**CITY OF BLOOMINGTON  
PLAN COMMISSION AGENDA  
June 10, 2013 @ 5:30 p.m.**

**BLOOMINGTON PLAN COMMISSION  
STAFF REPORT  
LOCATION: 320 N. Walnut Street**

**CASE#: SP-21-13  
DATE: June 10, 2013**

**BLOOMINGTON PLAN COMMISSION  
STAFF REPORT  
LOCATION: 319 N. Walnut Street**

### 4.) TREE PLOT:

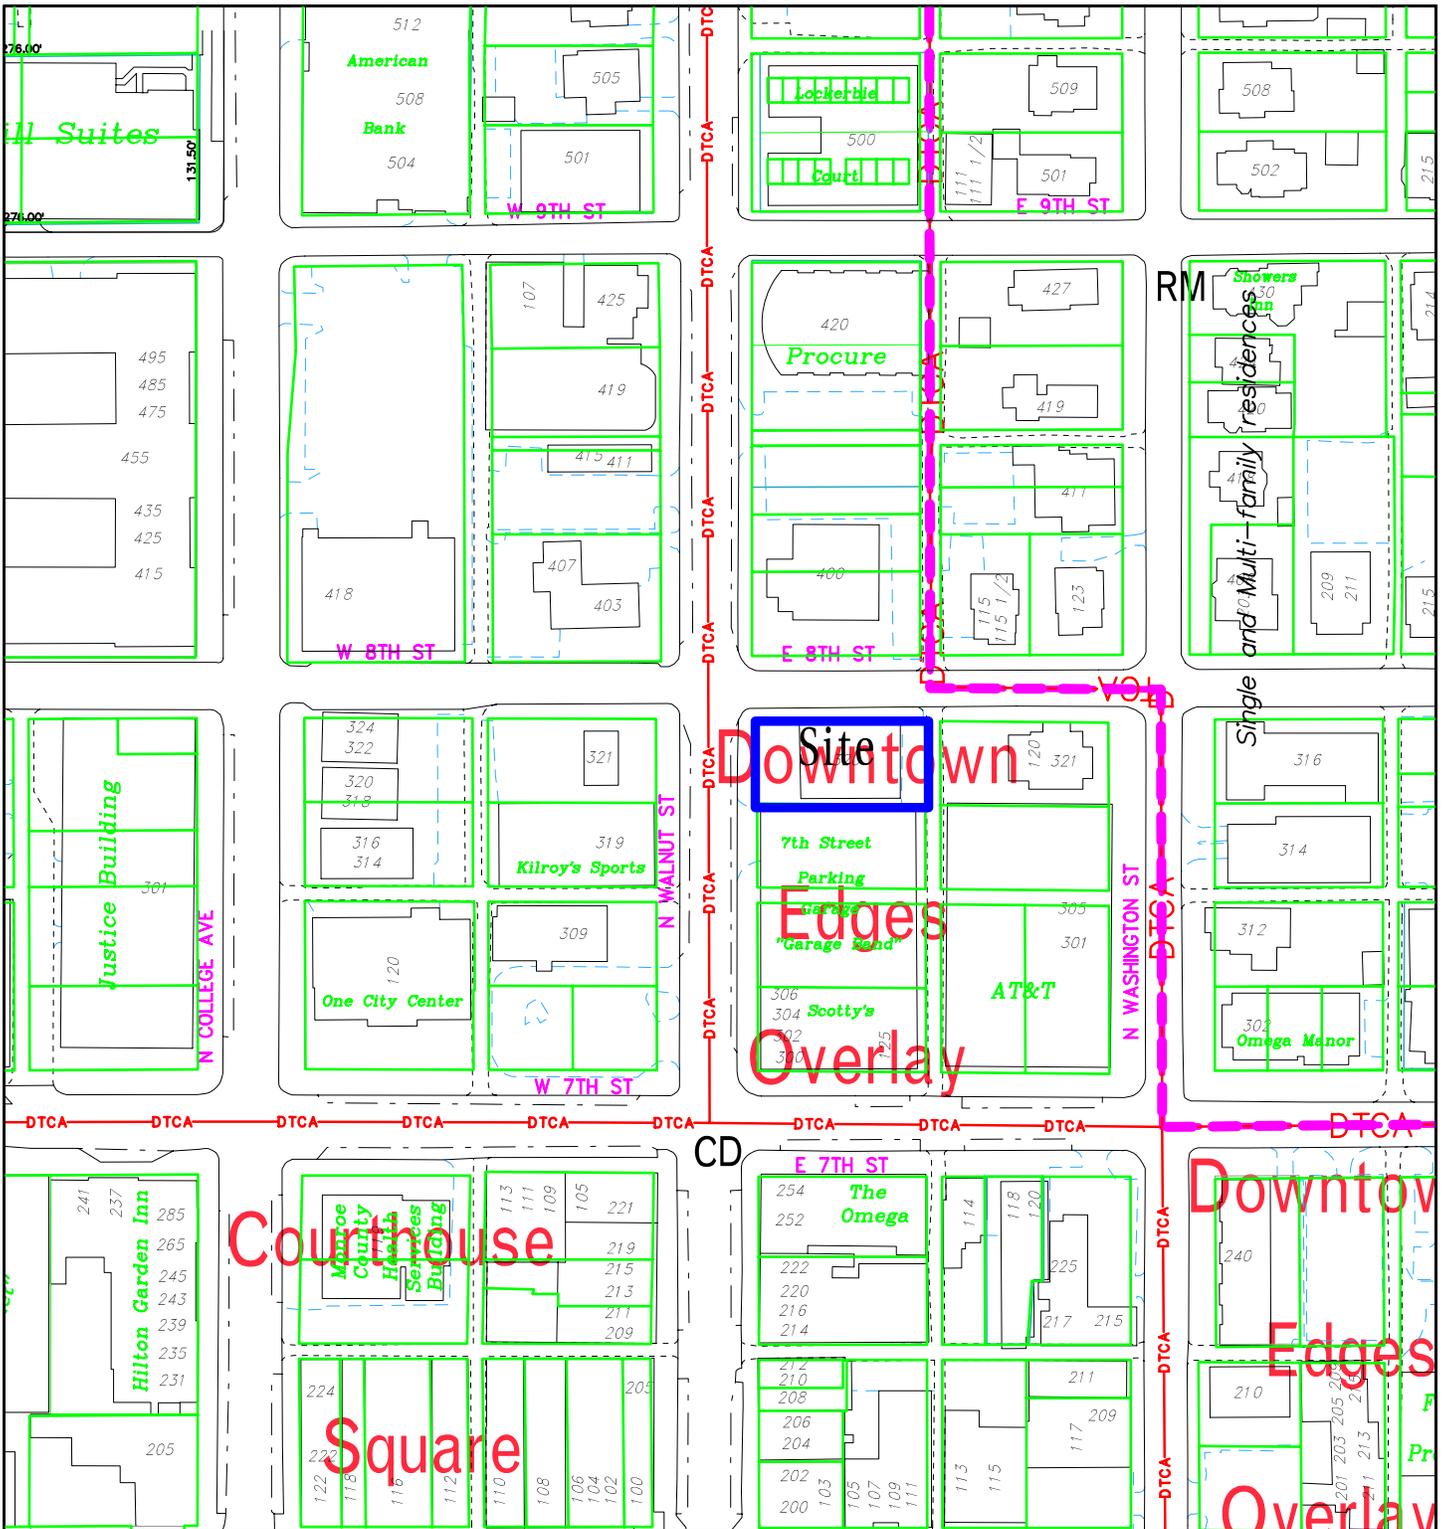
4.) The Petitioner should remove the obsolete concrete driveway in the tree plot and replace it with vegetation.

Because there used to be a parking lot in the front of the existing building, there is a drive cut through the tree plot that is no longer needed. The EC recommends that this concrete space that looks out of place now, be removed and used as it should be for a tree plot.

**Staff response:** The concrete driveway will be removed with this petition. This former drive has a curb along Walnut St. and could be reused as a bicycle parking area. If not used for bicycle parking, staff agrees that it should be removed.

**1** PROPOSED SITE PLAN  
1" = 10'

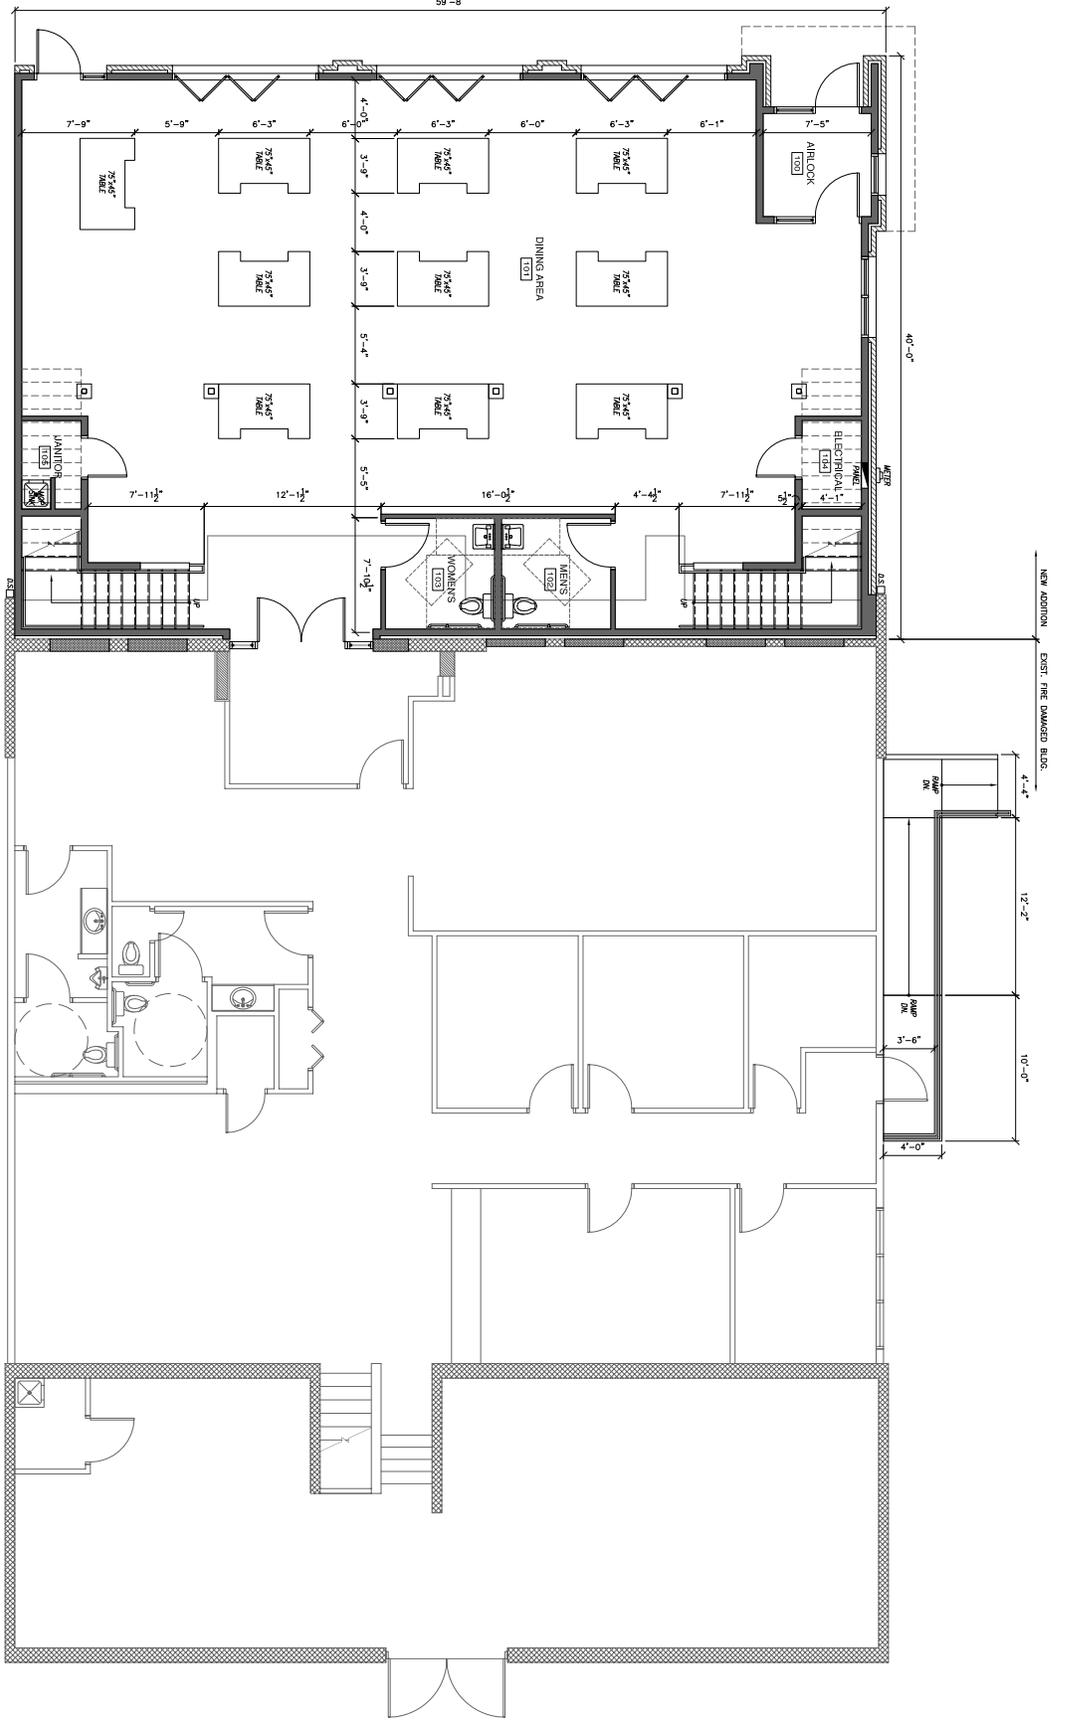
**Bicycle Parking:** The restaurant is required to have a minimum of 4 Class II bicycle parking spaces within 50' of the entrance. The property does not currently have a bike rack. A bike rack is required and must be shown on the site plan prior to issuance of a building permit. The remnant concrete pad from a previous driveway in front of the building provides an ideal location for the required bike parking.

**Landscaping:** The landscaping code requires open space to be planted to the extent practical. There is a 5' wide strip of open space along the north side of the existing building. Part of that area will be used for a new entry and ramp, however there will be some area remaining that can be landscaped. Staff will work with the petitioner to install landscaping to the extent practical in this small area.

1. One street tree is required along Walnut Street. The petitioner will work with staff to install landscaping where possible along the 8<sup>th</sup> Street frontage
2. A fence or other structure is required between this building and the parking garage to the south.
3. The existing concrete pad along Walnut St. must be removed if not used for bicycle parking.
4. One street light is required along 8<sup>th</sup> Street.
5. Street trees are required along 8<sup>th</sup> Street and will be coordinated with the Urban Forester for appropriate species.
